# Access Compliance Report

## Public Rights-of-Way

Intersection ID: 28626	Main Street: MILLERS_CREEK_LN	Cross Street: STUARTS_DRAFT_CT	Location: SE
ADA ID: 63F5ACD6BF5E	Ramp Type: PerpDiag	Initial Pass/Fail: Fail	Overall Compliance: No
Severity Score: 12.5			
Codes/Mitigation Info/Possible Solution		Field Measurements/Component Compliance

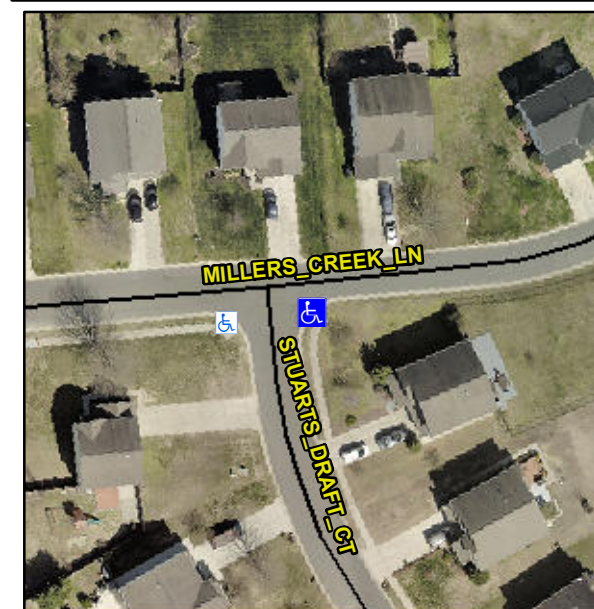
**Remove & Replace Curb Ramp With Two New Directional Ramps or Equivalent.**

**Not Found, R304.2.2**
